Certificate of Appropriateness

2843 W. STATE ST.

Raise second floor sun porch on east elevation.

PTS ID 45714 COA - Porch Restoration / Structural Repair

Center match or tongue-and-groove flooring

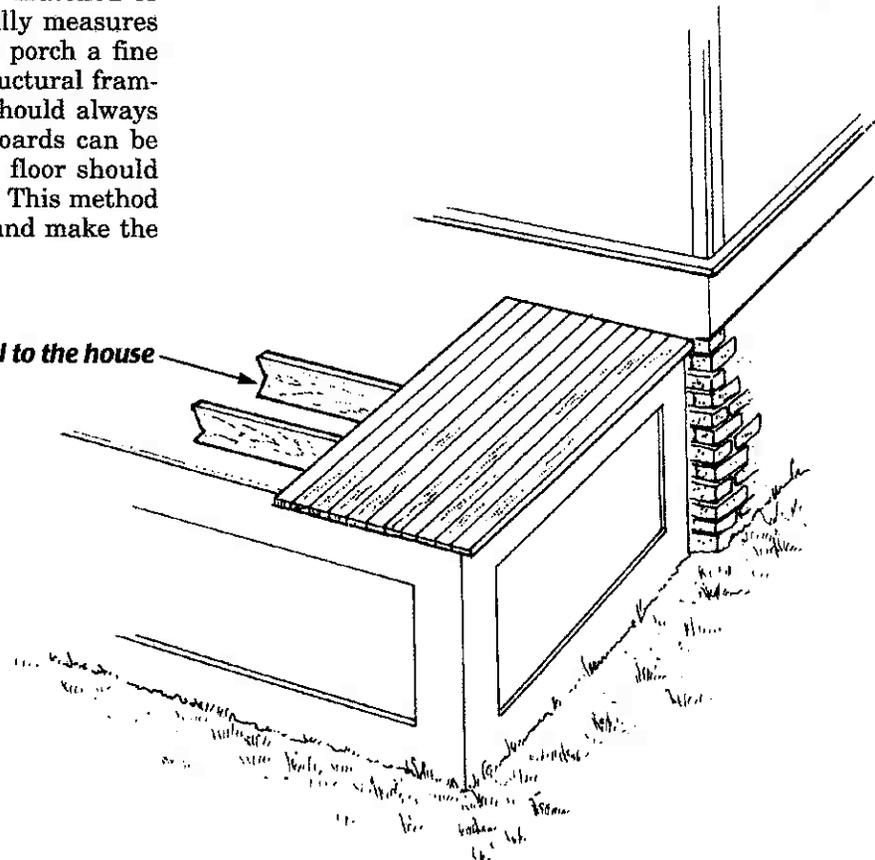
Traditional Porch Floors

Porch floors should be constructed of center matched or tongue-and-groove wooden flooring, which typically measures 2-1/4" wide by 3/4" thick. This flooring gives the porch a fine finished appearance. The joists, which are the structural framing members to which the flooring is attached, should always be run parallel to the house so that the floor boards can be installed perpendicular to the house. The porch floor should also be very slightly pitched away from the house. This method of construction for a porch floor will shed water and make the porch last longer.

Joists parallel to the house

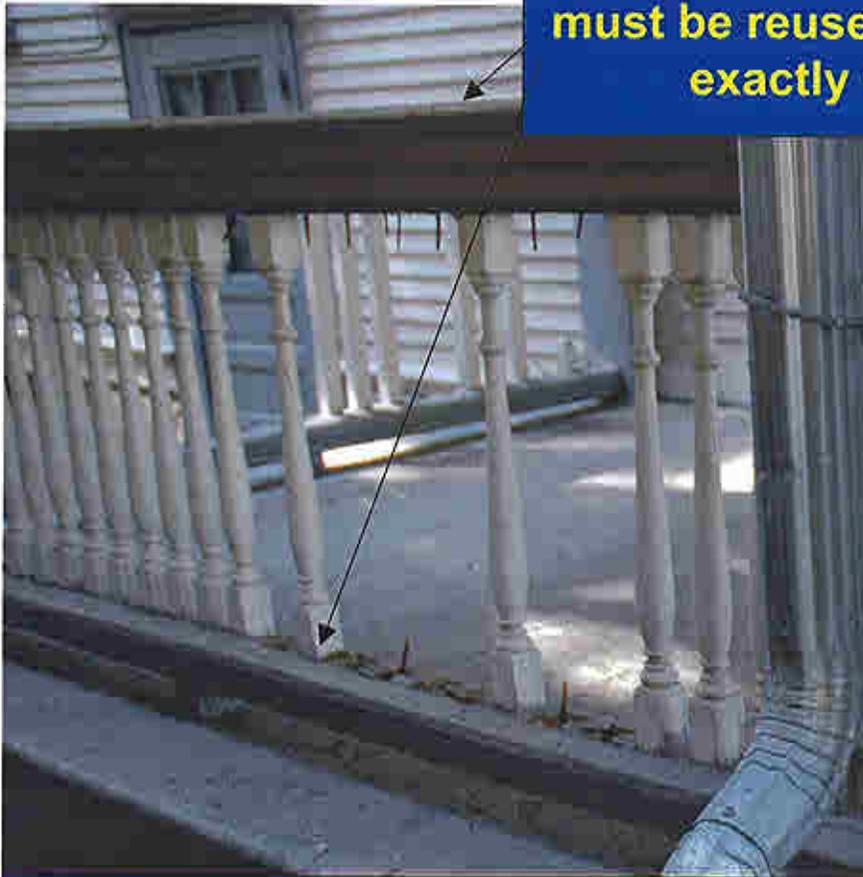
Latticework shall be reused or duplicated exactly as it is now.

Original guardrails on deck must be reused or duplicated exactly to match.

**Reuse existing square and round columns.
Bases may be repaired with structural wood epoxy or appropriate substitute
bases may be used that are approved by HPC staff.**

**Original guardrails on deck
must be reused or duplicated
exactly to match.**

**Reuse existing square and round columns.
Bases may be repaired with structural wood epoxy or appropriate substitute
bases may be used that are approved by HPC staff.**

**Reuse existing square and round columns.
Bases may be repaired with structural wood epoxy or appropriate substitute
bases may be used that are approved by HPC staff.**

Original guardrails on deck must be reused or duplicated exactly to match.

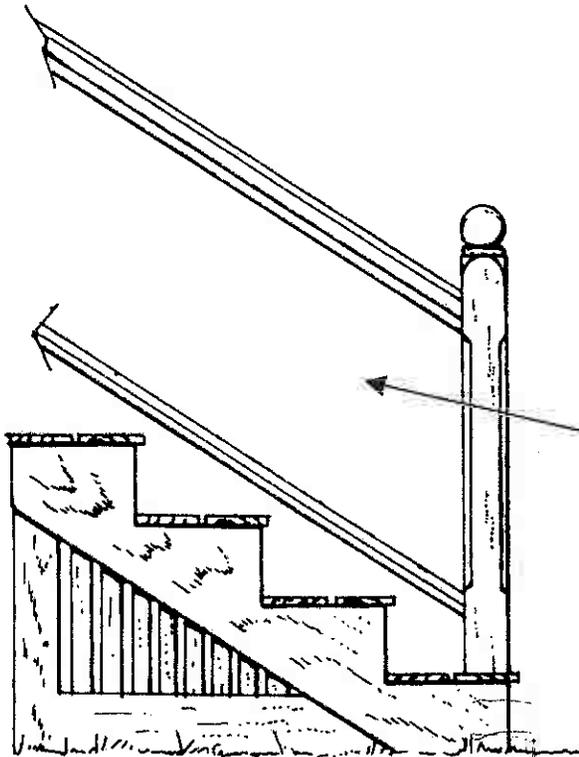
Side porch original balustrades.

Front porch missing balustrades.

Original turned balustrades from side porch may be removed as needed and reused on front porch. Matching turned or square balustrades may be used on the side and back of porch.

Alternative
box newel
for porch.

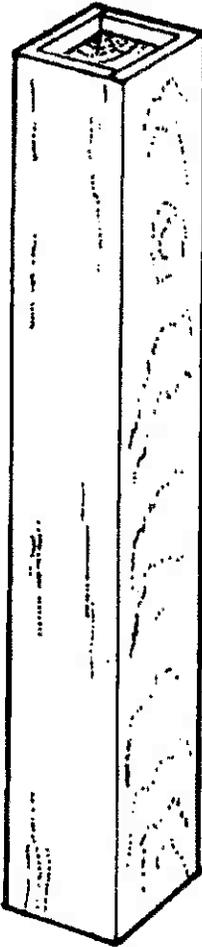
Side porch construction with solid newel post.

Place turned balustrades to match original.

The design of a staircase handrail should match the railing around the porch deck.
